**TECHNICAL BULLETIN**

Plenum Chamber Drain Valve –  
Distorted – Water Entering ECM –  
Service Action S619

MODEL 1995 MY  
XJ12 Sedan  
VIN 720001-725767

ILLUSTRATION 1

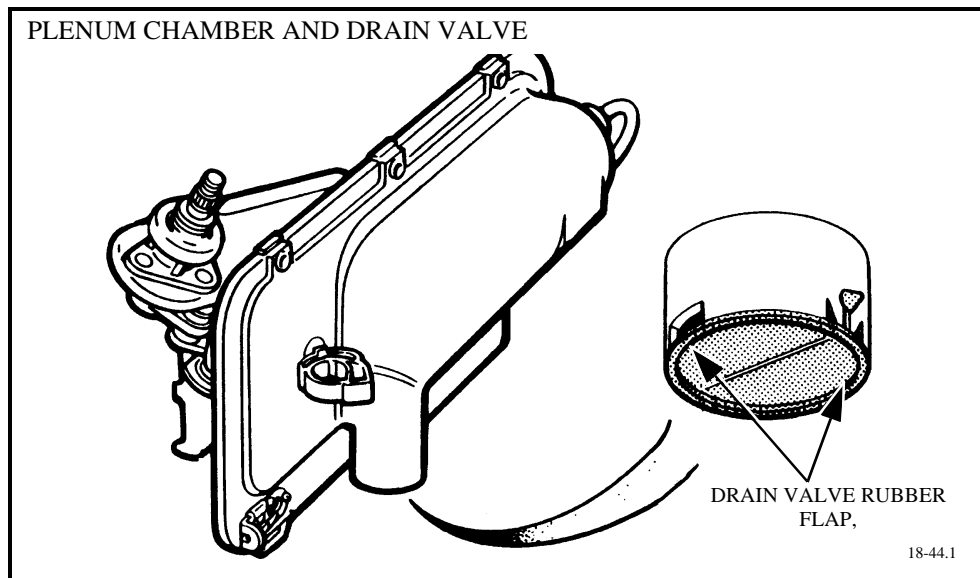
At the next service opportunity, or during PDI, check the plenum chamber drain valve rubber flap (Illustration 1) of all 1995 MY Sedan Range vehicles within the VIN range. Follow the procedure described below.

1. Visually inspect the drain valve rubber flap using a light and mirror.
  - If the drain valve rubber flap is in the correct position, as shown in Illustration 1 above, no further action is required.

ILLUSTRATION 2

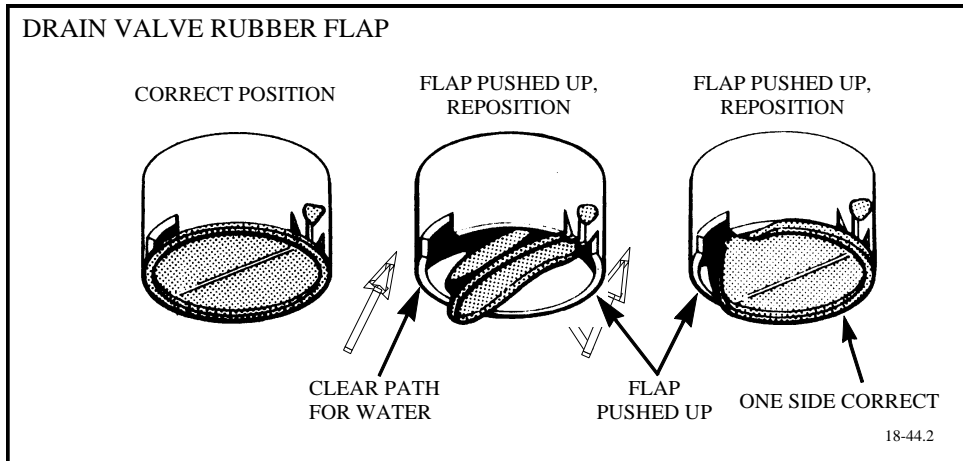
- If the rubber flap is pushed up, with one side open to allow a clear path for water drain (Illustration 2) or with one side in the correct position, reposition the flap to the correct position with the fingers. No further action is required.

**NOTE:** The rubber flap must be free from the drain tube walls to allow water to drain.

ILLUSTRATION 3

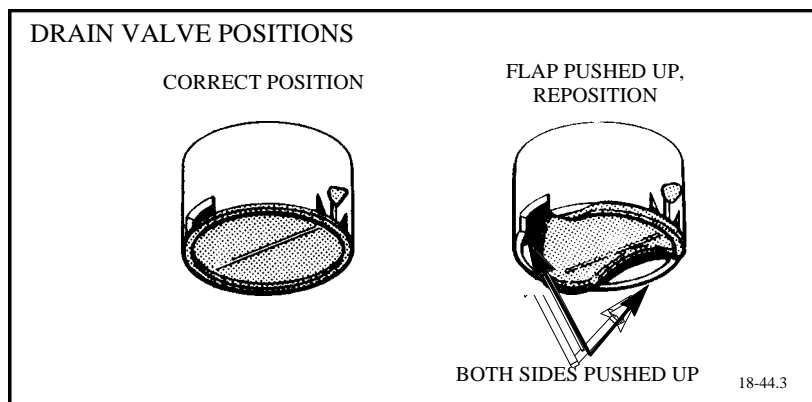
- If the rubber flap is pushed up into the drain tube, with both sides restricting water flow (Illustration 3), reposition the flap to the correct position with the fingers and check the ECM for signs of water damage.
